**MAINE TURNPIKE AUTHORITY**

**ADDENDUM NO. 6**

**CONTRACT 2022.07**

**INTERCHANGE IMPROVEMENTS**

INTERCHANGE IMPROVEMENTS  
 SACO (EXITS 35 & 36)  
 BARRIER DETAILS 1  
 NOTES

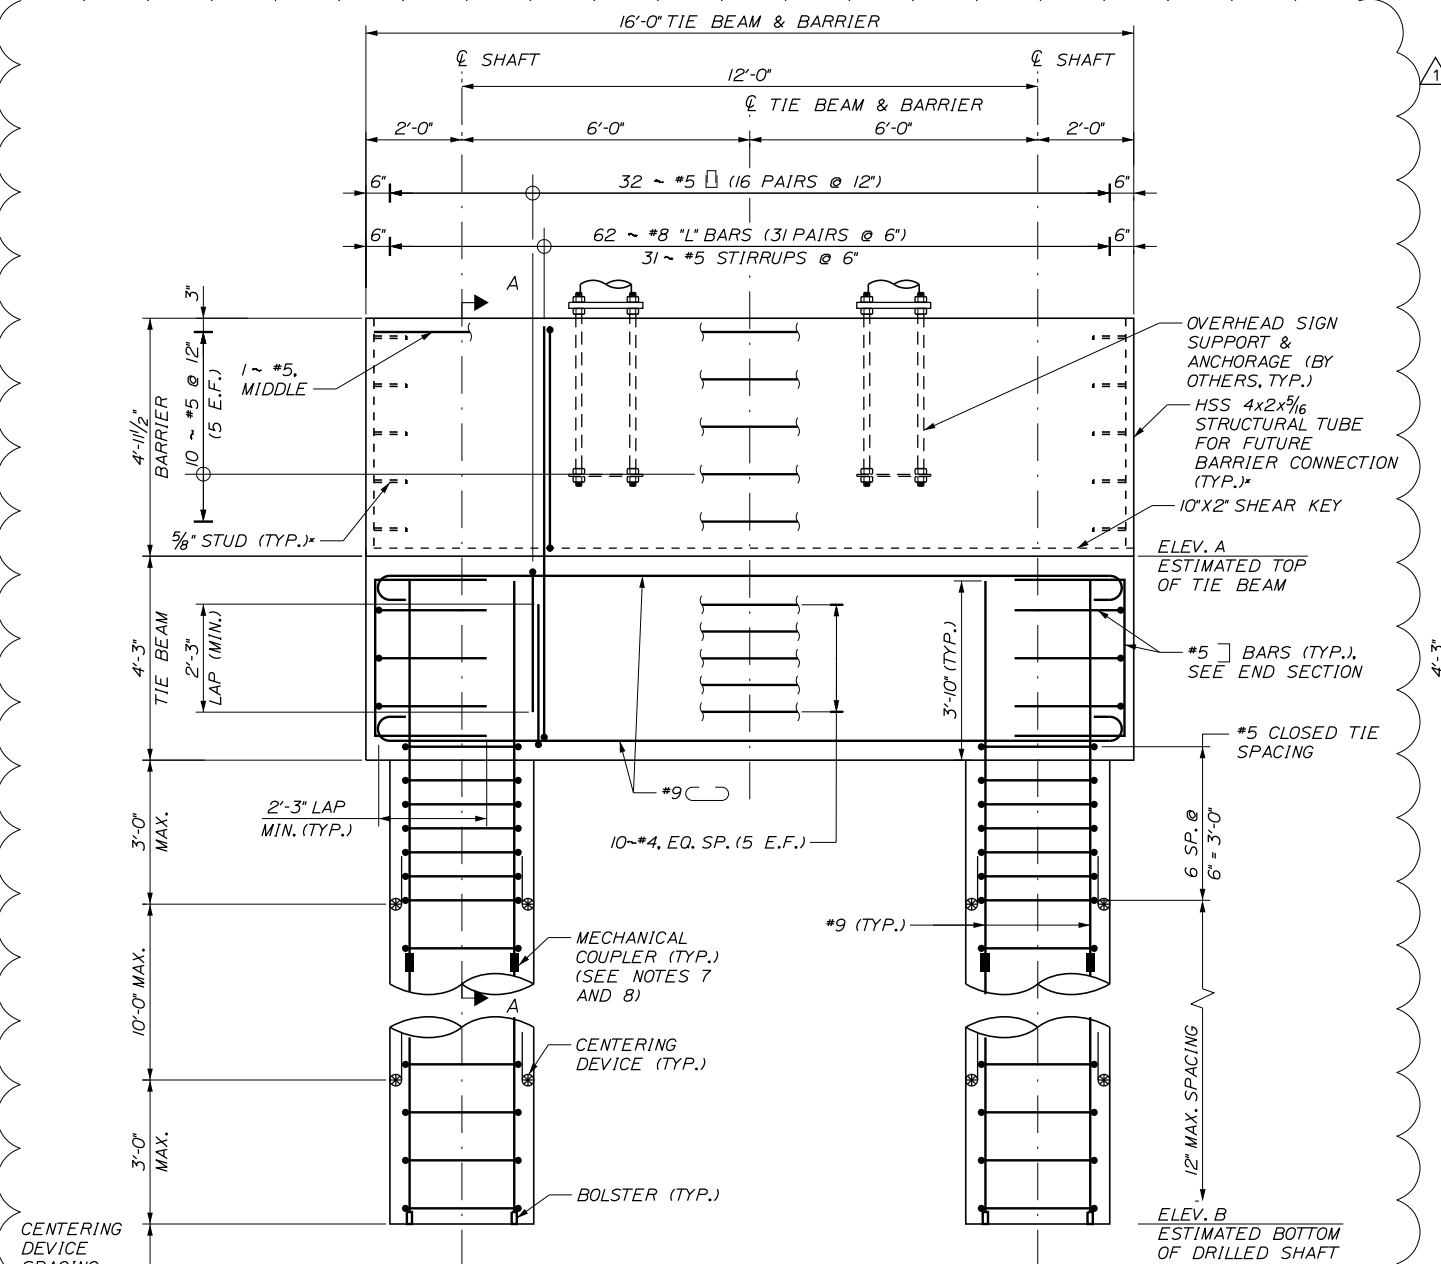
3. Question: How does the roadway curvature affect the Type A barrier spacing detail on sheet 102?

**Answer:** A note has been added to sheet 102 in Addendum No. 6 to require tapering the barrier ends as necessary to maintain the barrier spacing on curved alignments.

INTERCHANGE IMPROVEMENTS  
SACO (EXITS 35 & 36)  
OVERHEAD SIGN  
FOUNDATION DETAILS (1 OF 3)

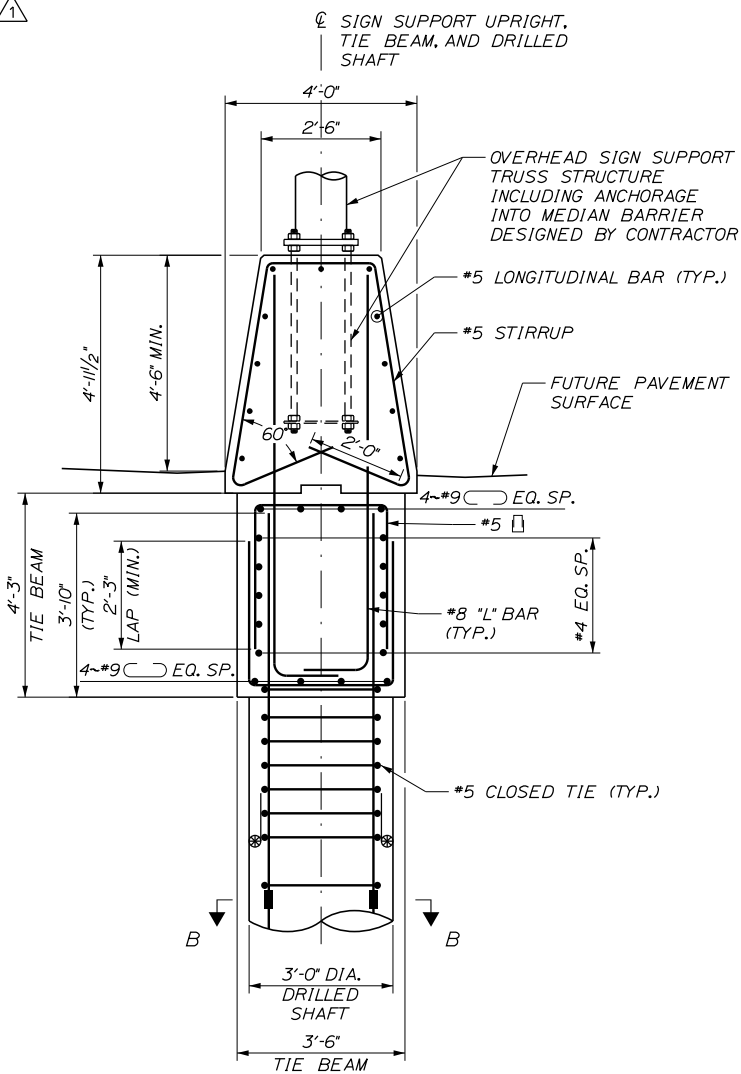
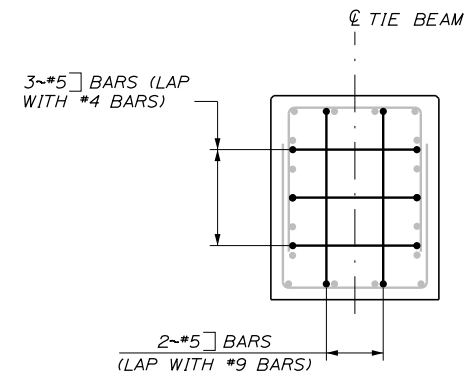
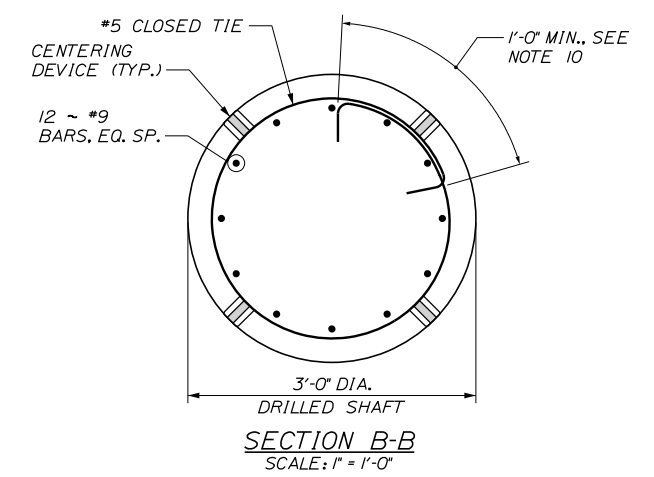
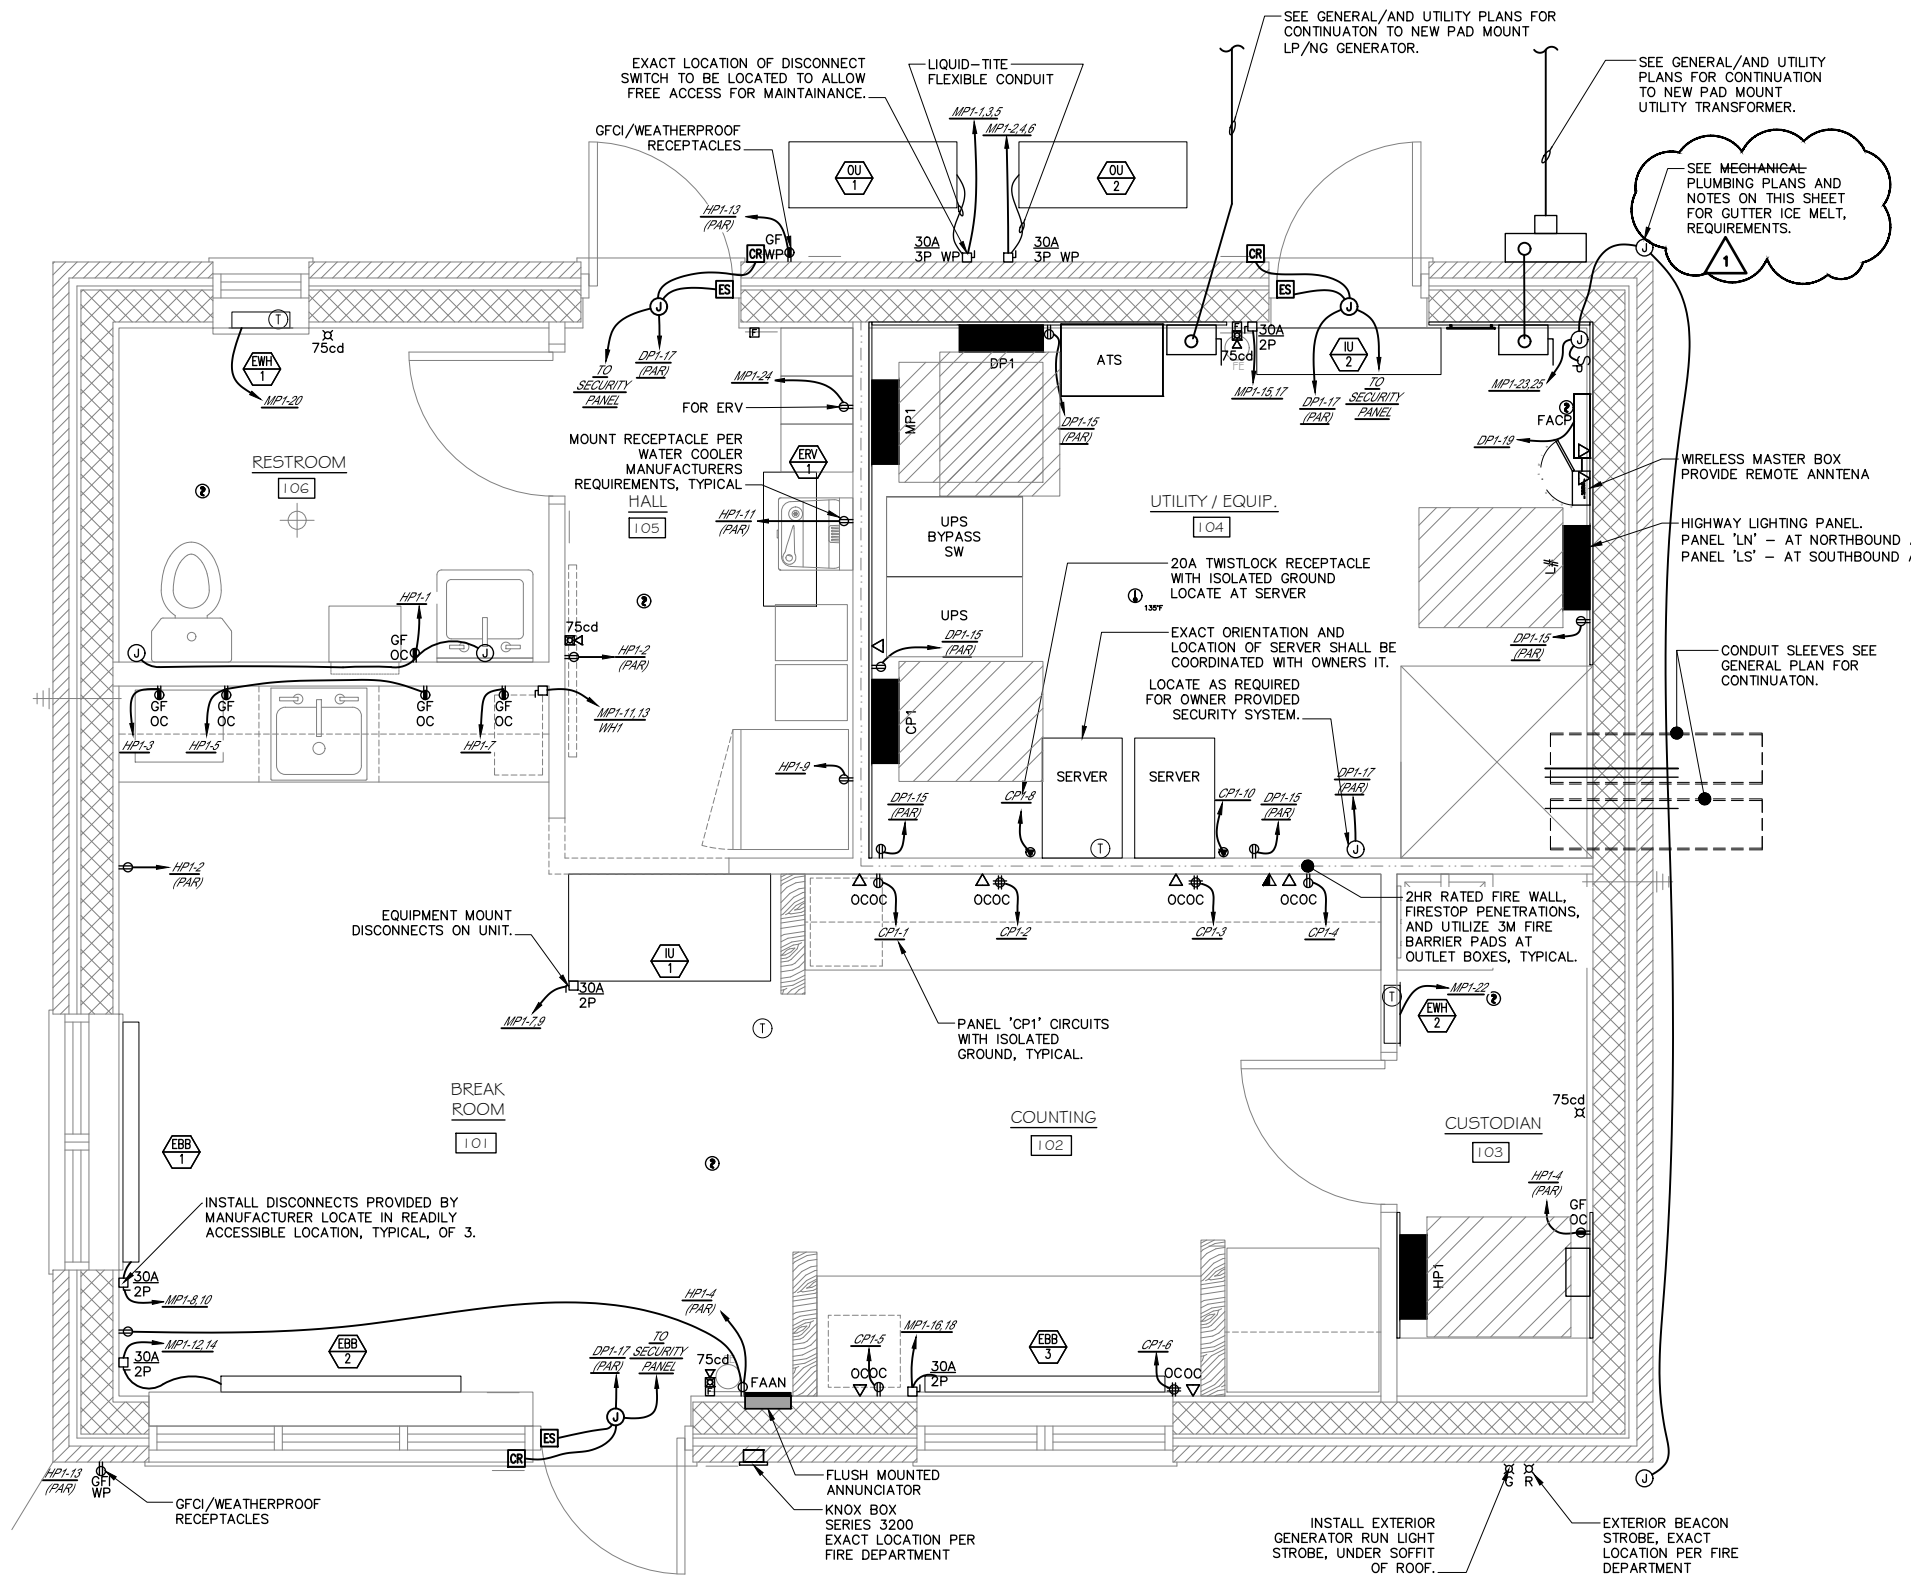
2. Question: Does the sign support barrier shown on sheet 242 require any connection detail for connecting to future barrier?

**Answer:** Connection detail notes have been added in Addendum No. 6.

INTERCHANGE IMPROVEMENTS  
SACO (EXITS 35 & 36)  
TOLL ADMINISTRATION BUILDING  
ELECTRICAL POWER PLAN - SB

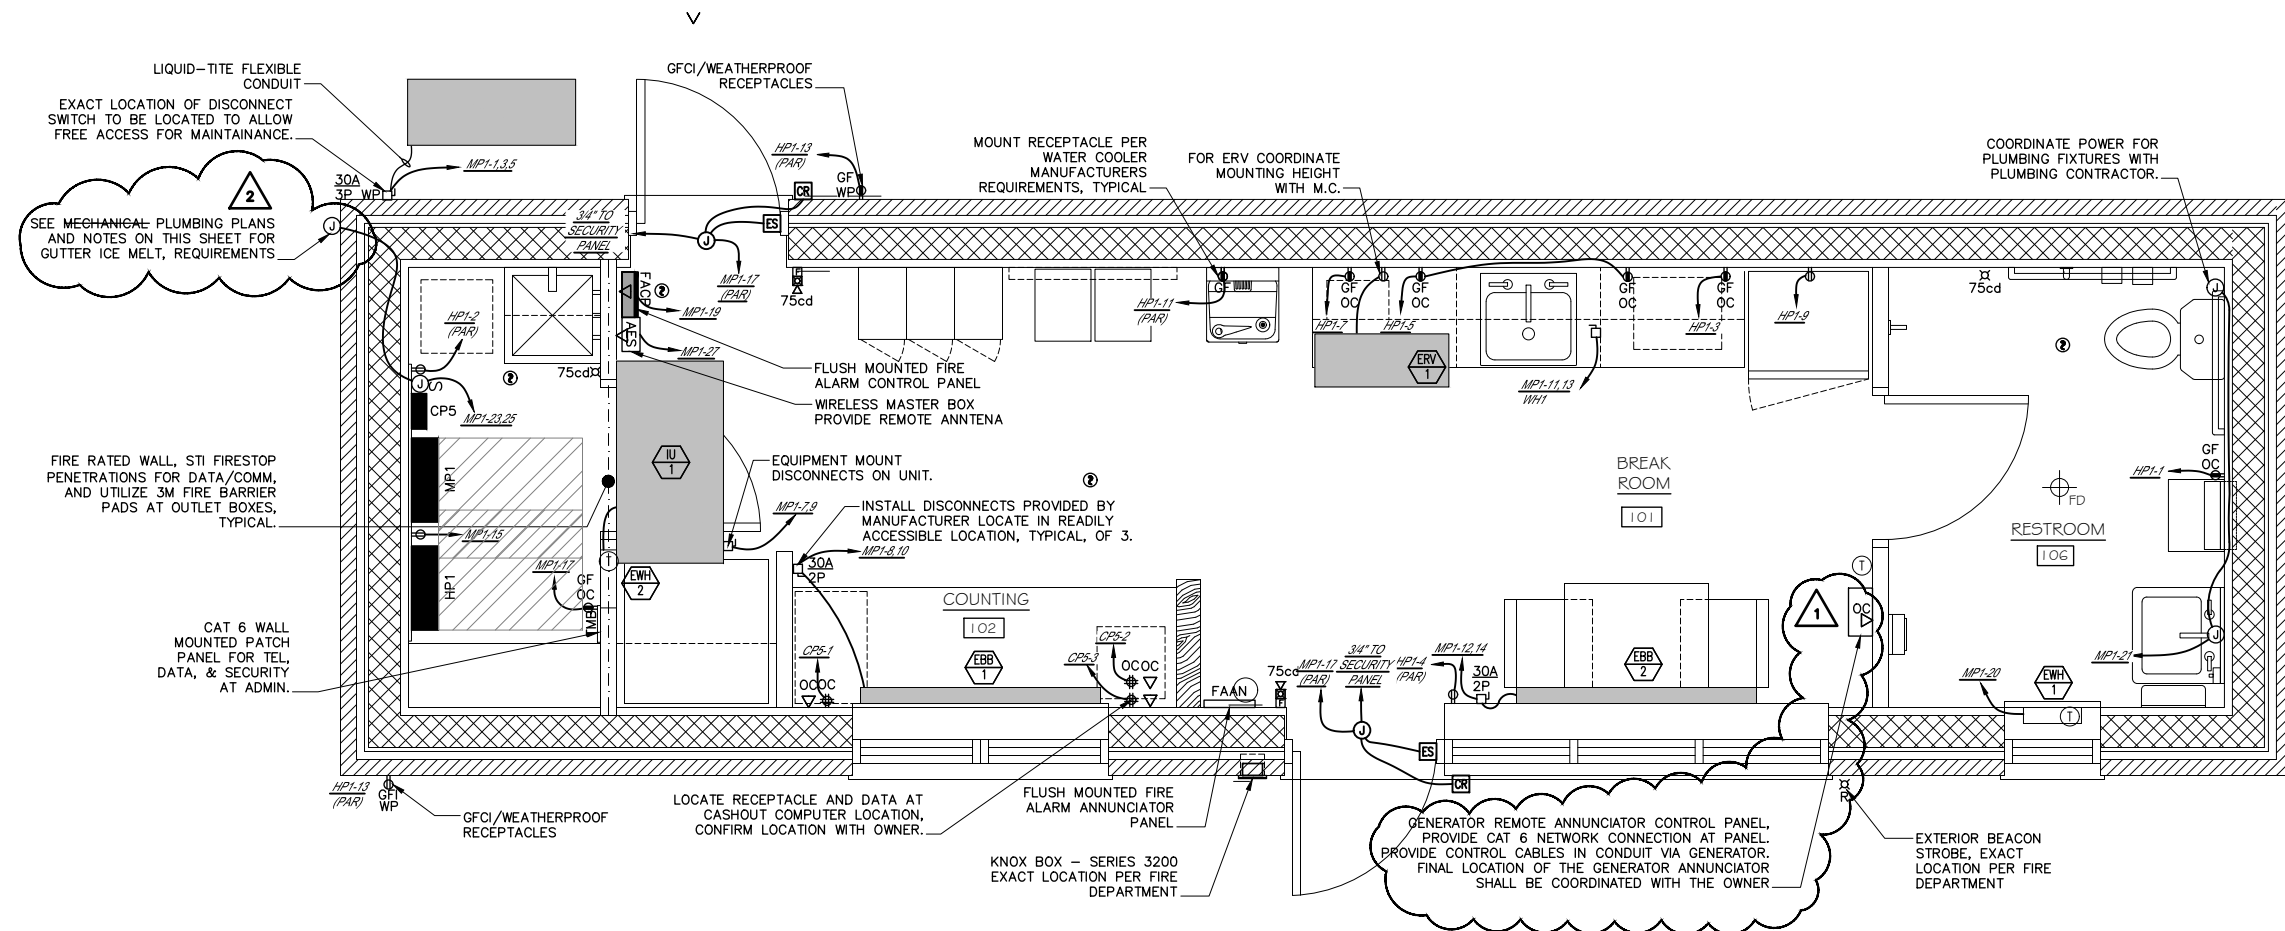
1. Question: Sheets E101 and E201 have a note on the building saying “See Mechanical plans for Gutter Ice melt requirements” but the mechanical plans do not show any de-icing information.

**Answer:** The notes on Sheets E101 and E201 have been revised in Addendum No. 6 to refer to the plumbing plans and notes on E101.
